Hills of Gold Wind Farm

Submission

Brian Tomalin
67 Regans Road,
Tamworth NSW 2340
Phone: 0427 693 626
Email: tomalinb@northnet.com.au

Appendix I

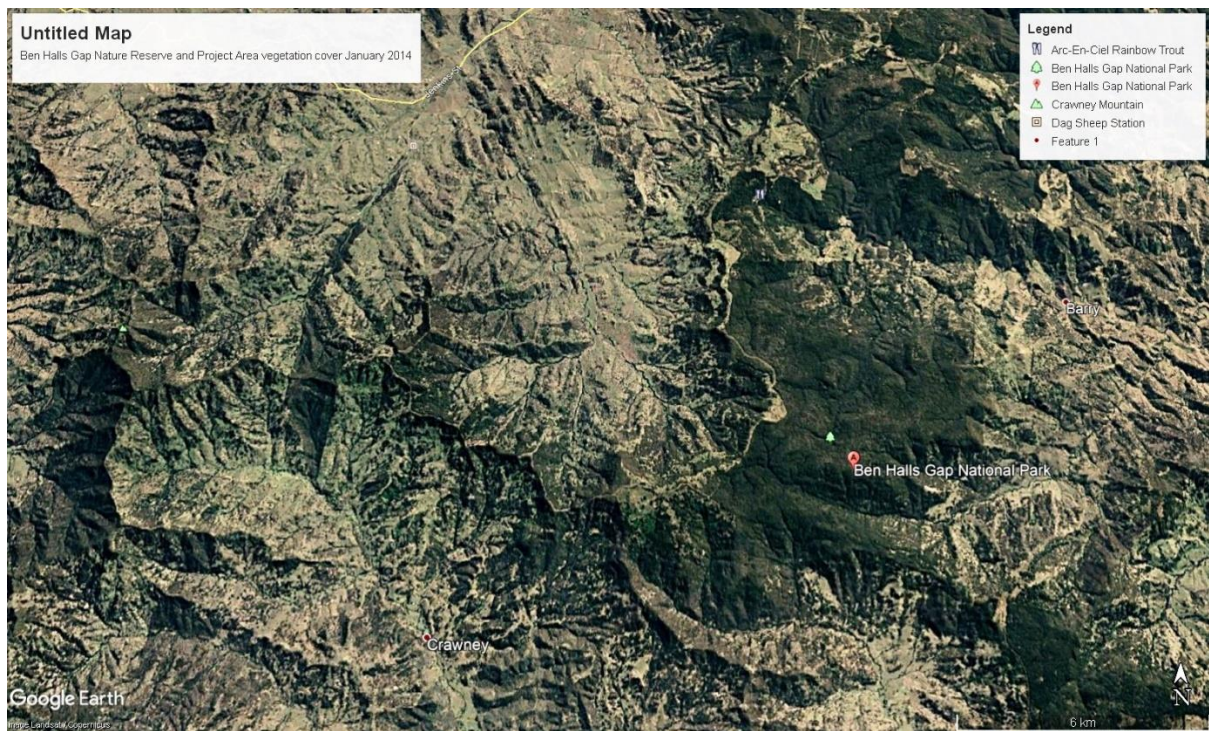
The properties within the project area have a history of sheep and cattle grazing. The majority of the area from WP1 to WP22 excluding WP21; WP39 to WP42; WP46, to WP58 was not cleared for grazing prior to 2014. (Appendix I)

Caves and Caves North Fire Duration: 08/12/2009 to 18/12/2009
Map date: 17/12/2019 Area Burnt: 4,171.41 ha

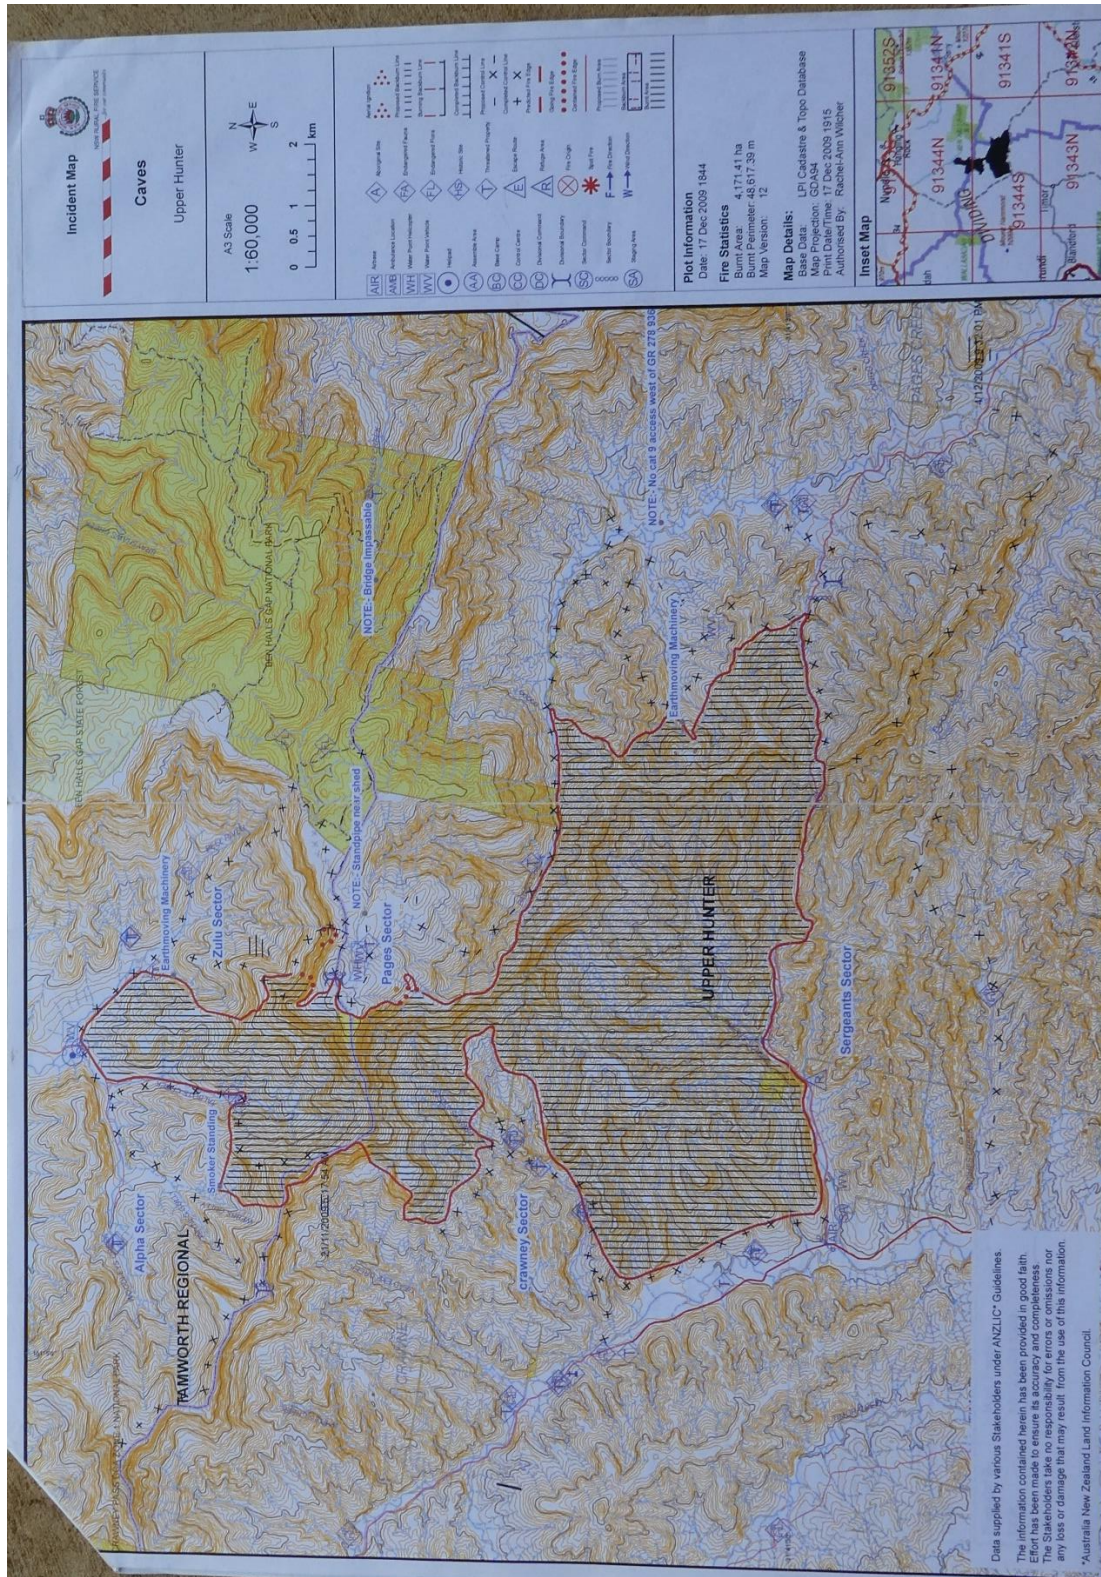
- Caves and Caves North – 08/12/2009 to 18/12/2009 (Sergeants Gap Road in south to Kirks Road in north) (Appendix 3)

Hanging Rock Fire Scenario

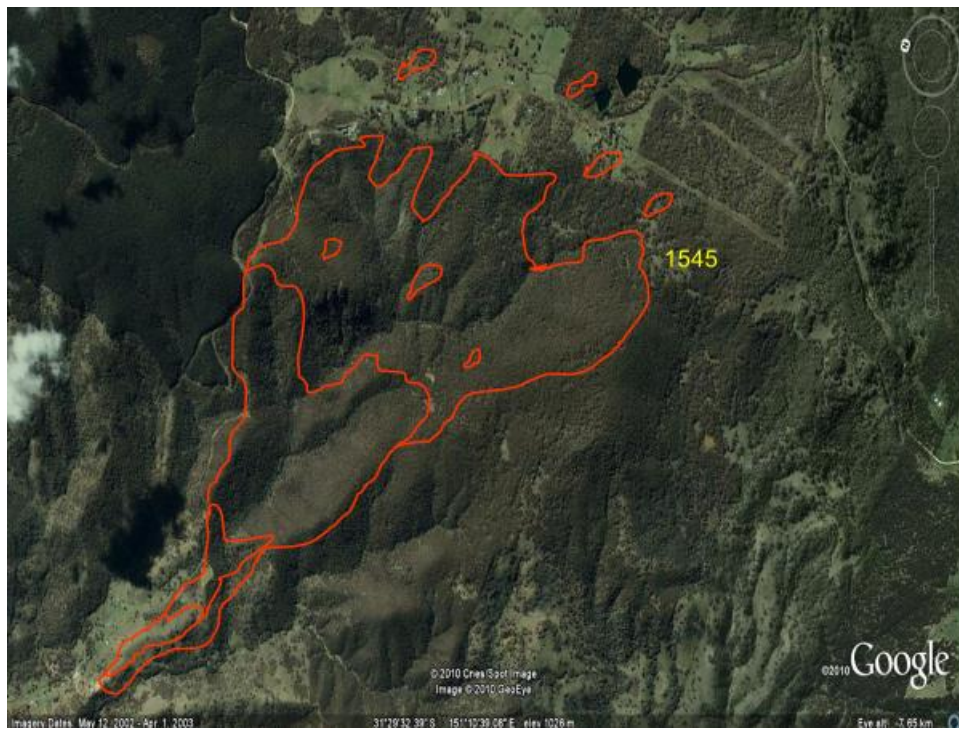
No specific modelling is available for the project area. RFS modelling of a fire starting near the Nundle Sawmill, on a day of mild conditions could engulf Hanging Rock Village within 2½ hours if not controlled within the first hour. A distance of approximately 4km with a rise of 400 metres. The speed of spread is influenced by slope not weather in this instance. (Appendix 4)

Wind driven frozen mist formed on the windward side of a fence and tree at “Nycooma” August 1983

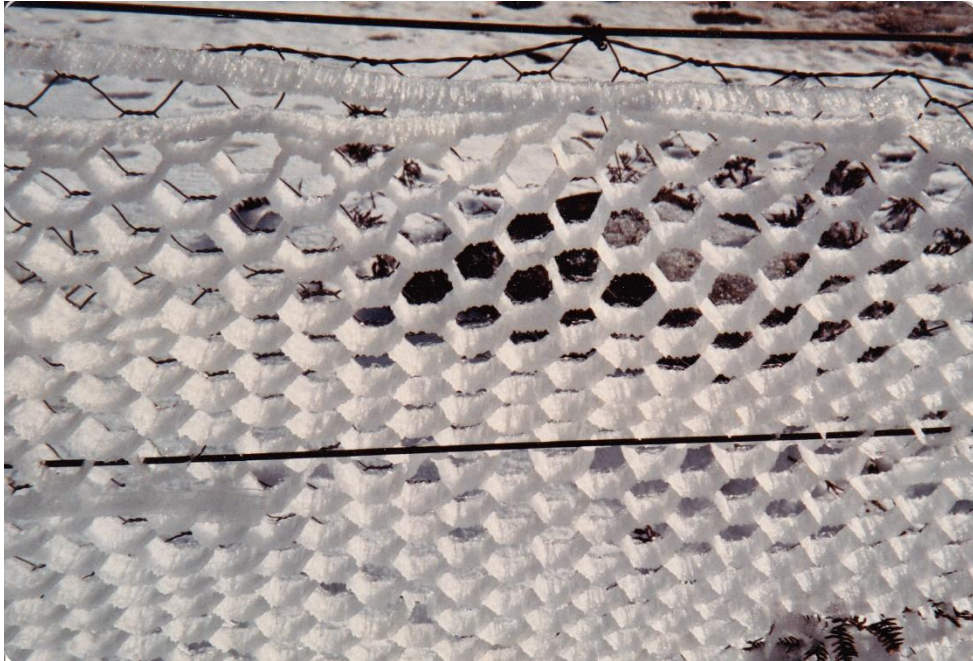
An issue that does not appear to be covered in the EIS is blade icing.

In periods of low cloud, freezing temperature and high wind the mist freezes and forms ice on the windward side of all exposed objects including fences and vegetation. (Appendix 8). In such conditions the effect on turbine blades would be the same as ice forming on aircraft wings.
